**NOTICE OF DECISION TO CONSENT TO AMEND A REFERRED PROPOSAL
DURING ASSESSMENT**

Australian Vanadium Project – Mining and Beneficiation Operations
Assessment No.2287

Attachment 1- Amended proposal content document and figure/s showing the amendments

Figure 1.1 Development Envelopes and Disturbance Footprint (Indicative Site Layout)

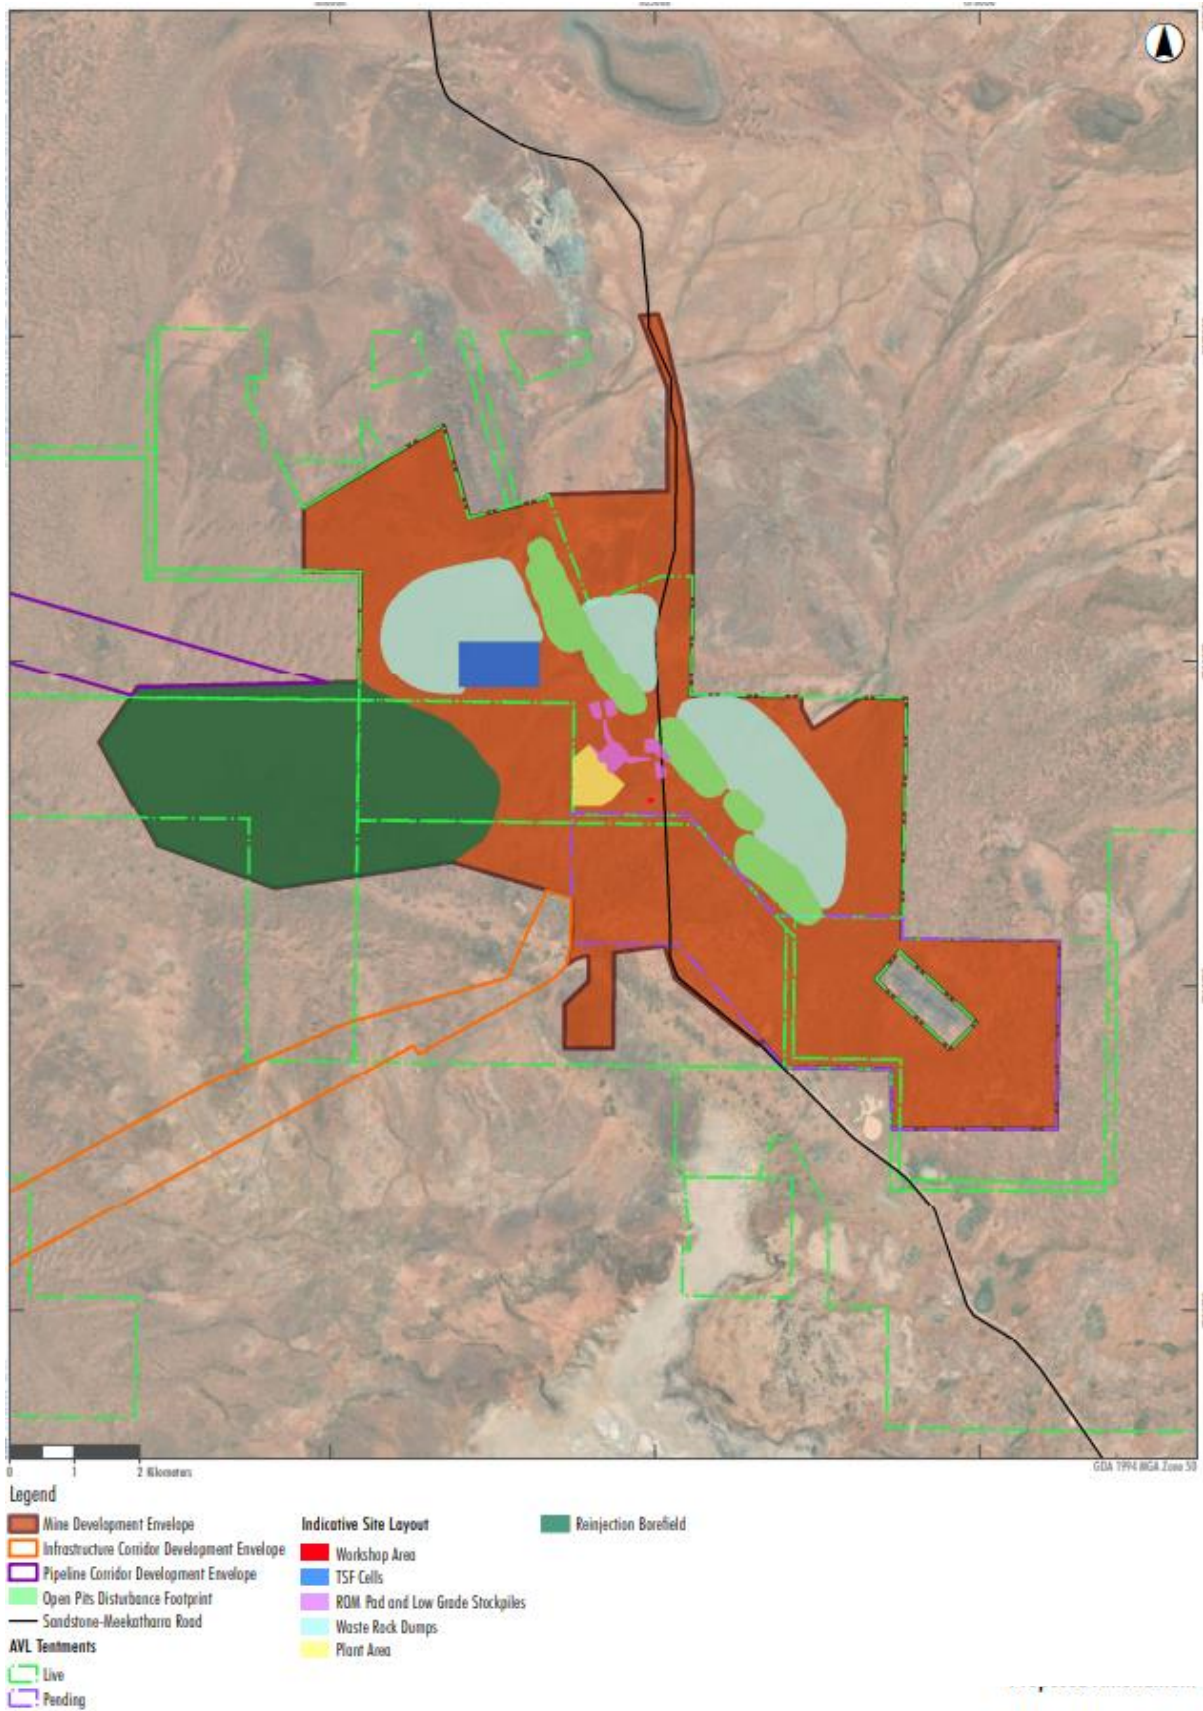
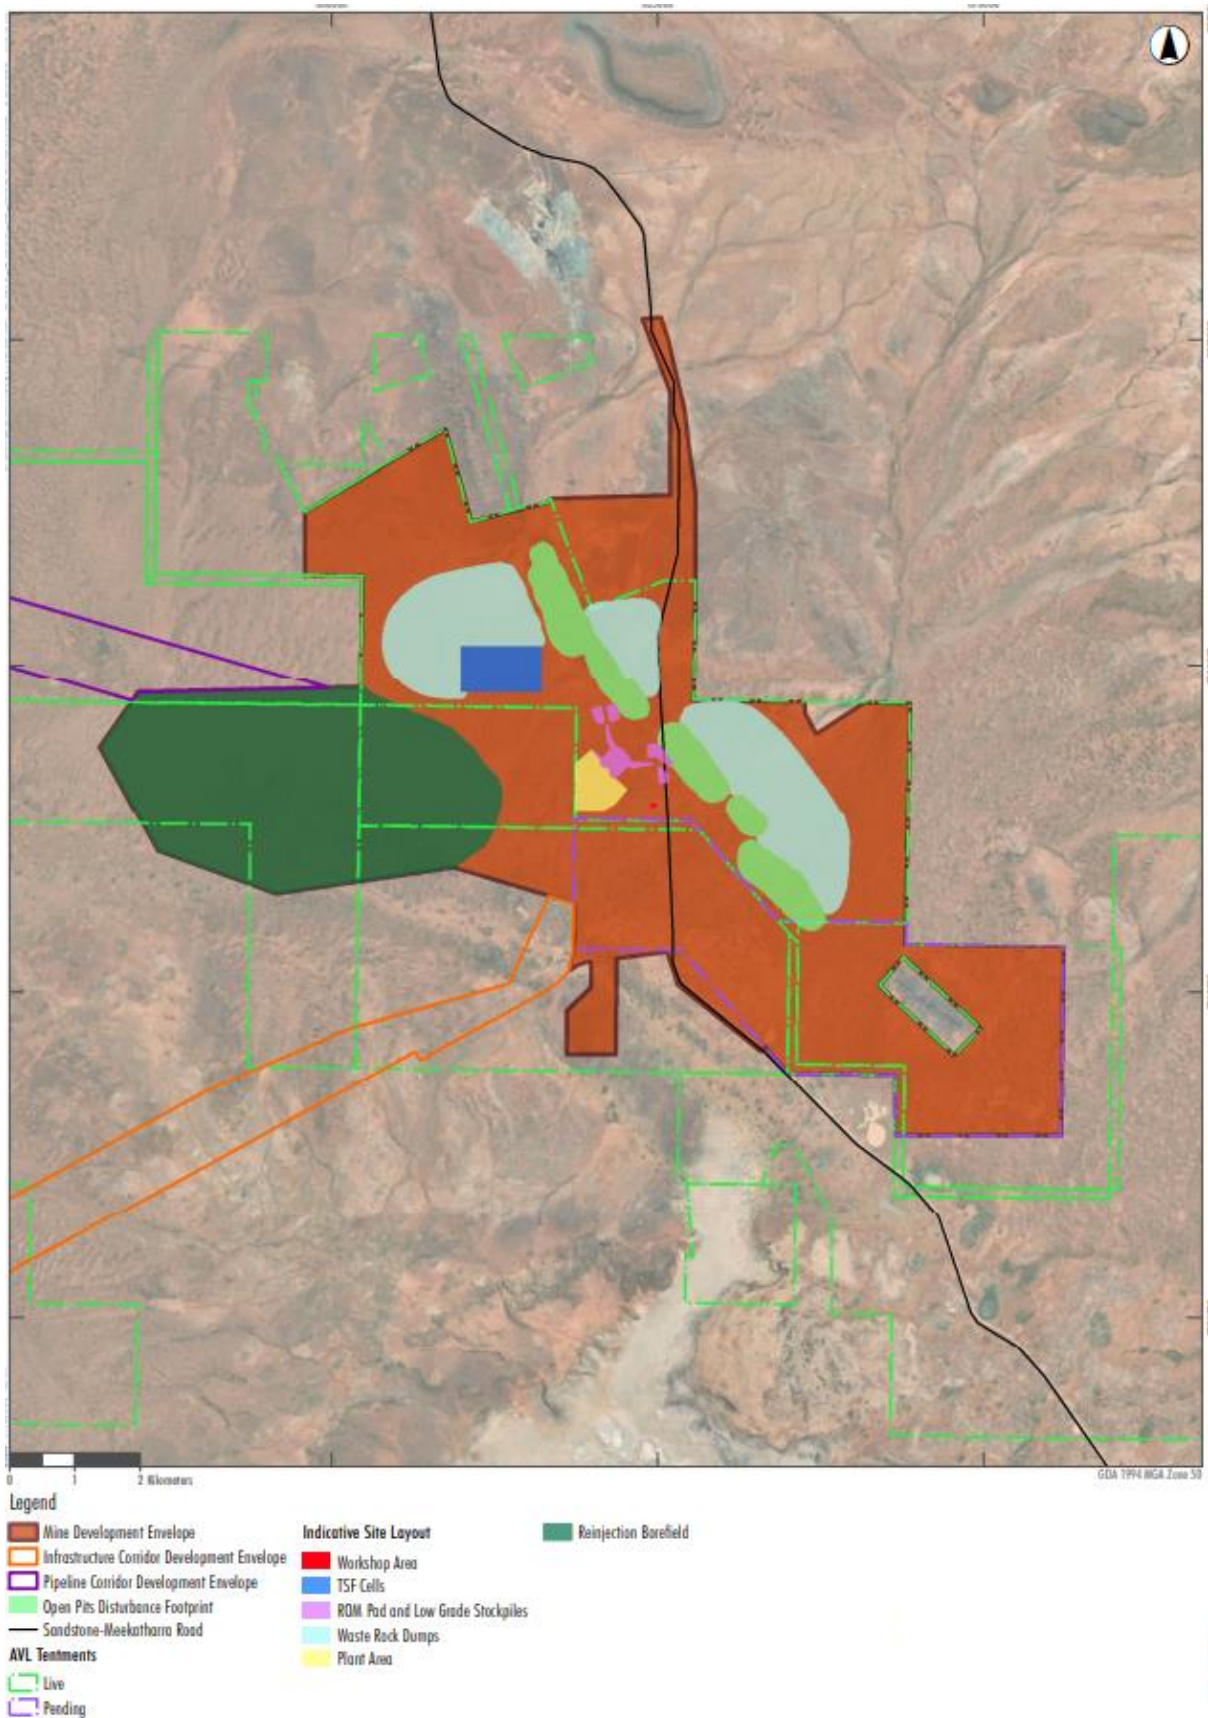
- Overall change in the development envelopes (including mining, access road and infrastructure corridor and pipeline corridor): 10,935 ha to 12,020 (increase of 1,085 ha [10%]).
- Overall change in the disturbance footprint: 3,806 ha to 2,657 ha [decrease of 1,149 ha [30%]].
- Removal of physical element Meekatharra-Sandstone Rd Diversion
- New element – pipeline corridor development envelope (2,430 ha) and disturbance area (47 ha).
- Water Abstraction – identification of groundwater impact zones.
- Disposal of excess water - reinjection of up to 4.4 GL/a water to the deep aquifer within the boundary of the reinjection Borefield and/or discharge (of up to 2.6 GL/annum) via pipeline to Lake Annean.
- Addition of Ore production rate.
- Minor word changes.

Element	Original Proposal	s.43a (Amended Proposal)
Mine, Beneficiation and Associated Infrastructure	Clearing of no more than 2,700 ha of native vegetation within the 8,295 ha Mine Development Envelope	Clearing of no more than <u>1,940 ha</u> of native vegetation within the <u>6,965 ha</u> Mine Development Envelope.

Reinjection to groundwater	-	<u>Reinjection of up to 4.4 GL/a water to the deep aquifer within the boundary of the reinjection borefield. Salinity of the reinjected water may range from brackish to hypersaline.</u>
Discharge of excess water to Lake Annean		<u>Discharge of up to 2.6 GL/a of water to Lake Annean via pipeline. Salinity of discharged water may range from brackish to hypersaline.</u>
Ore production rate	-	<u>Up to 1.0 up to 2.2 million tonnes per annum.</u>
Beneficiation Waste	Disposal of no more than 920,000 tpa of iron-sinks rejects (tailings	Disposal of no more than 920,000 tpa of <u>tailings solids</u> into the Integrated Waste Landform tailings cells.

Reinjection Groundwater	to Figure 1.1	Reinjection of up to 4.4 GL/a water to the deep aquifer within the boundary of the reinjection borefield. Quality of the reinjected water may range from brackish to hypersaline.

Proposal element	Location / description	Maximum extent, capacity, or range
Discharge of excess water to Lake Annean	Figure 1.1	Discharge of up to 2.6 GL/a of water to Lake Annean via pipeline. Quality of the discharged water may range from brackish to hypersaline
Beneficiation Waste	Figure 1.1	Disposal of no more than 920,000 tpa of tailings solids into the Integrated Waste Landform tailings cells.
Proposal elements with greenhouse gas emissions		
Peak Annual Average:		
Scope 1	Mine Facility: 63,775 t CO ₂ -e per annum	
Scope 2	Not Applicable	
Scope 3	Transport within WA and Processing Facility: 142,905 t CO ₂ -e per annum	
Commissioning		
<i>Construction and commissioning will not exceed the physical and operational elements detailed above</i>		
Rehabilitation and Decommissioning		
<i>Rehabilitation and decommissioning will be undertaken in accordance with the Mine Closure Plan, which will be approved and administered by the Department of Mines, Industry Regulation and Safety.</i>

Figure 1.2 Infrastructure Corridor Development Envelope

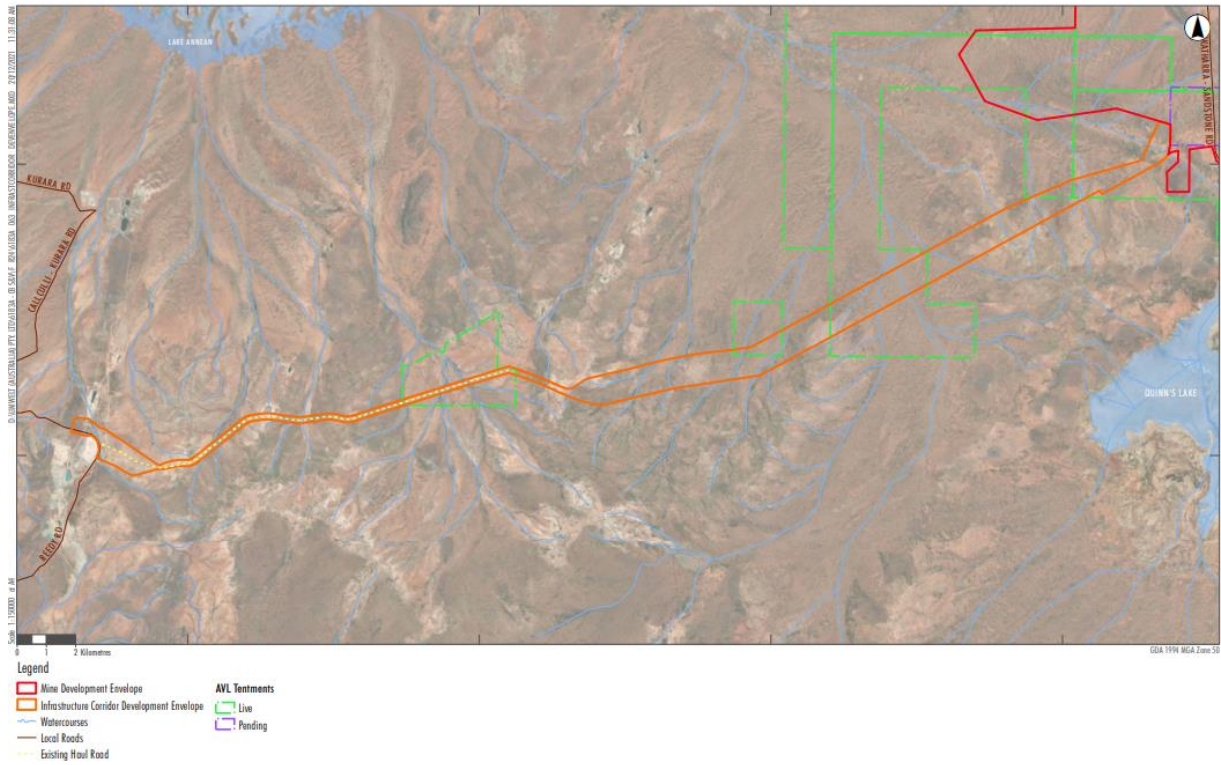
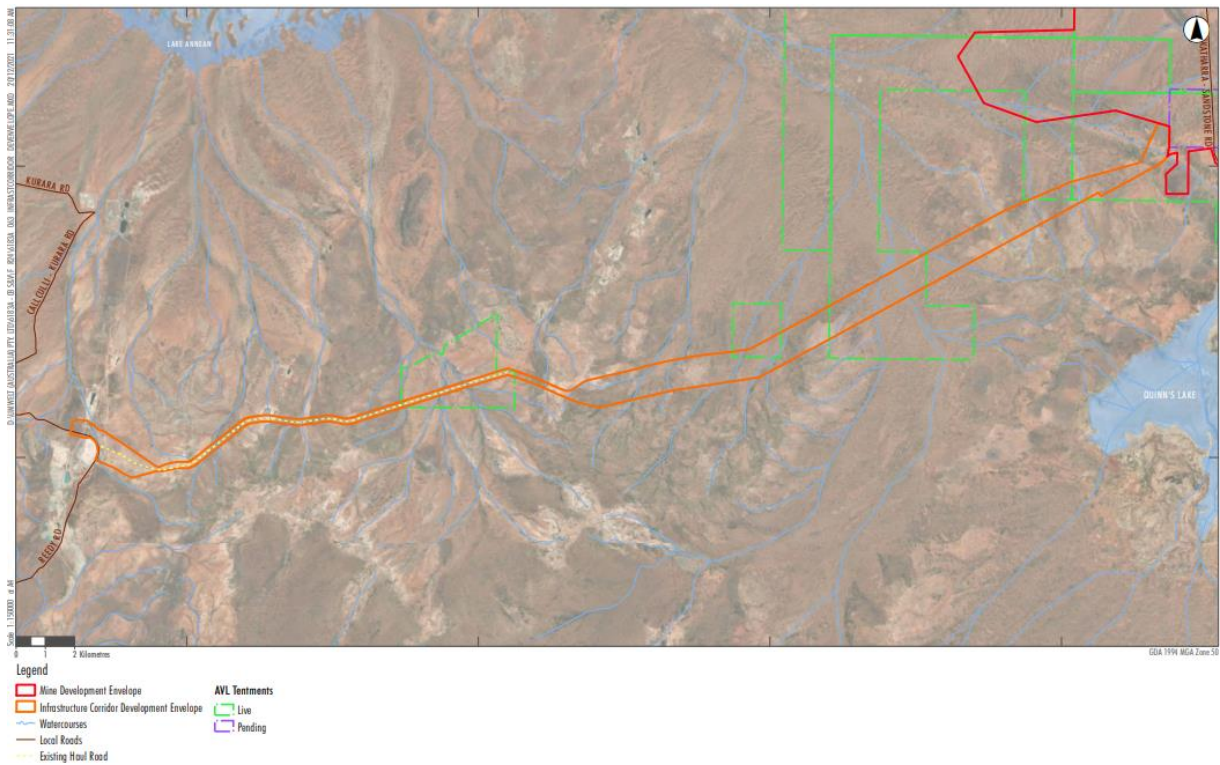
Element	Original Proposal	s.43a (Amended Proposal)
Meekatharra-Sandstone Rd Diversion	Clearing of no more than 6 ha of native vegetation within the 15 ha Diversion Development Envelope	Removed.
Access Road and Infrastructure Corridor	Clearing of no more than 1,100 ha of native vegetation within the 2,625 ha Infrastructure Corridor Development Envelope.	Clearing of no more than <u>670 ha</u> of native vegetation within the 2,625 ha Infrastructure Corridor Development Envelope.
Pipeline corridor	-	<u>Clearing of no more than 47 ha of native vegetation within the 2,430 ha Pipeline Corridor Development Envelope.</u>
Open Pits	The open pits cover a combined maximum surface area 350 ha within the Open Pits Disturbance Footprint.	<u>The maximum depth of the open pits is 250 mAHD.</u>
Groundwater Abstraction	Groundwater abstraction of no more than 3 GL/a.	Groundwater drawdown as a result of implementing the proposal: <u>Groundwater drawdown (groundwater depth compared to baseline groundwater level prior to commencing groundwater abstraction) does not extend:</u> <ul style="list-style-type: none"> • <u>beyond 10 m of groundwater drawdown;</u> and • <u>outside of the High Groundwater Impact Zone.</u> <u>Outside of the Partial Groundwater Impact Zone, groundwater drawdown remains less than 2 m.</u>

Figure 1.3 Pipeline Corridor Development Envelope

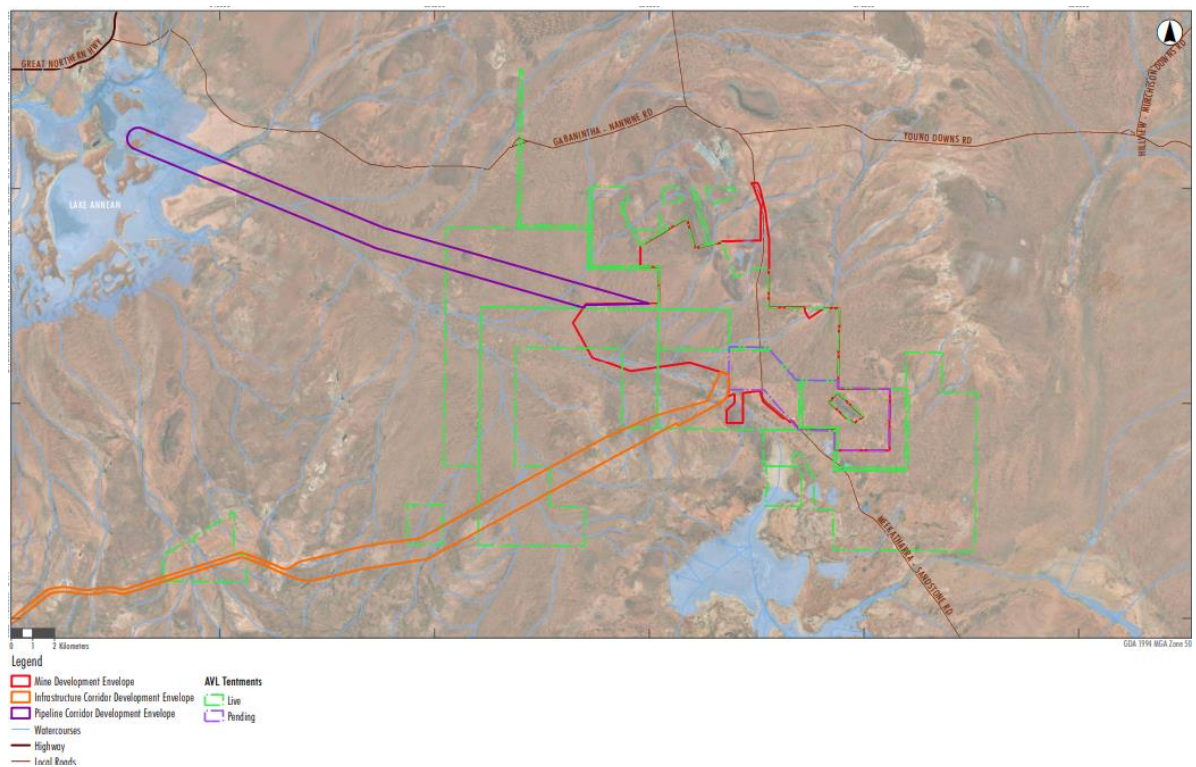
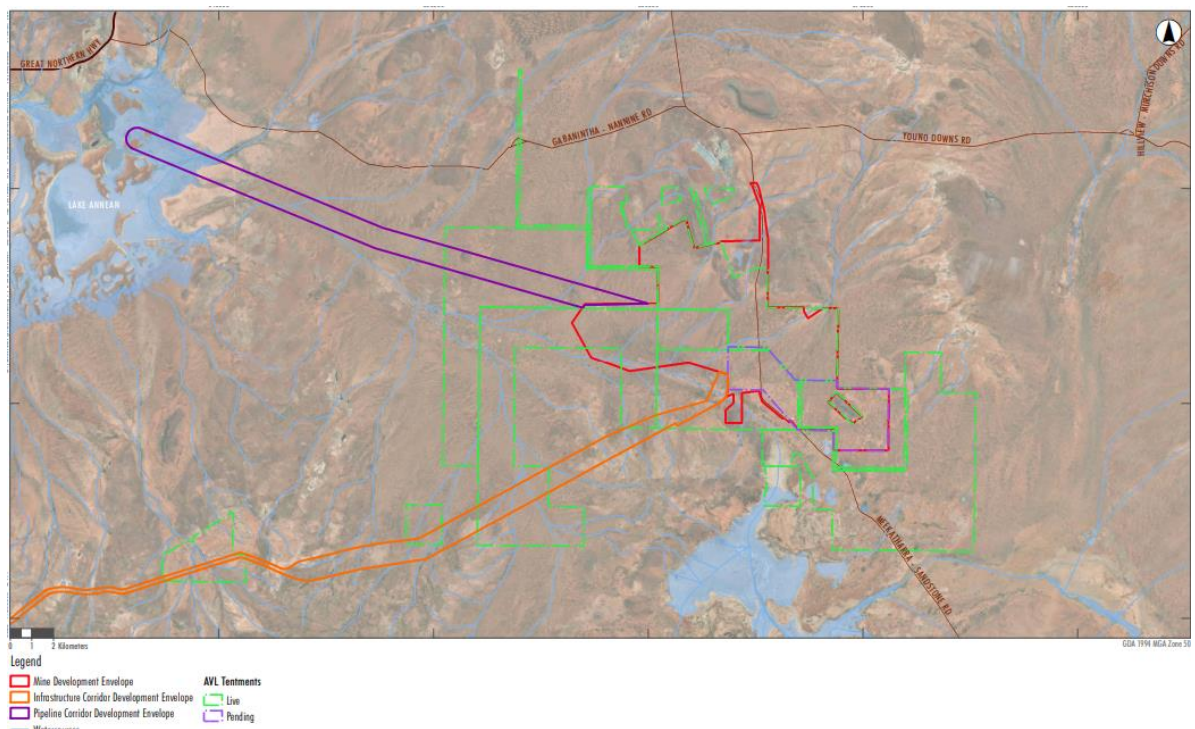
Table 1 provides an overview of the proposed amendments which more accurately reflect updated hydrogeological modelling predictions. The Development Envelope for the Mine and associated infrastructure is to be reduced by 1,330 ha from 8,295 ha to 6,965 ha. The proposed clearing associated with this area has also been reduced by 760 ha. There is also a reduction in clearing within the Infrastructure Corridor Development Envelope. There is an addition of a pipeline corridor Development Envelope (2,430 ha) with clearing of up to 47 ha of vegetation. Excess water is proposed to be discharged via a managed aquifer recharge (MAR) reinjection borefield and/or pipeline to Lake Annean (Pipeline corridor).

Amendment sought	Changes to environmental impacts
<ul style="list-style-type: none"> Discharge of up to 2.6 GL/a via pipeline to Lake Annean <p>Therefore, a potential combined disposal of excess water of up to 7GL/a.</p>	<p>Likely increased impacts to:</p> <p><u>Reinjection to Deep Aquifer</u></p> <ul style="list-style-type: none"> The reinjection Borefield will be in the Hope Palaeodrainage main channel. Groundwater investigations to date indicate that the deep aquifer where the reinjection to occur is saline. The reinjection of brackish to hypersaline excess water into the deep aquifer is not anticipated to have a significant impact on the receiving environment. Further, modelled reinjection scenarios indicated that high salinity water propagated laterally within the deep aquifer, with limited vertical exchange within the lower portion of the lacustrine clay facies. High salinity water is not expected to invade the shallow aquifer under the increased pressure of reinjection to the deep aquifer. (Umwelt 2022). <p><u>Lake Annean</u></p> <ul style="list-style-type: none"> Lake Annean and its habitat are known to support some migratory birds. Groundwater data for Lake Annean indicates that it is a hypersaline system with recorded salinity levels ranging from 150,000 mg/L and 170,000 mg/L (PSM 2022). There may be discharge of up to 2.6 GL excess hypersaline to brackish water into lake. <p>The EPA considers proposed changes do not alter the key environmental factors (Inland Waters, Subterranean Fauna and Terrestrial Fauna) likely to be impacted by the original proposal. These impacts will be considered during the assessment.</p>
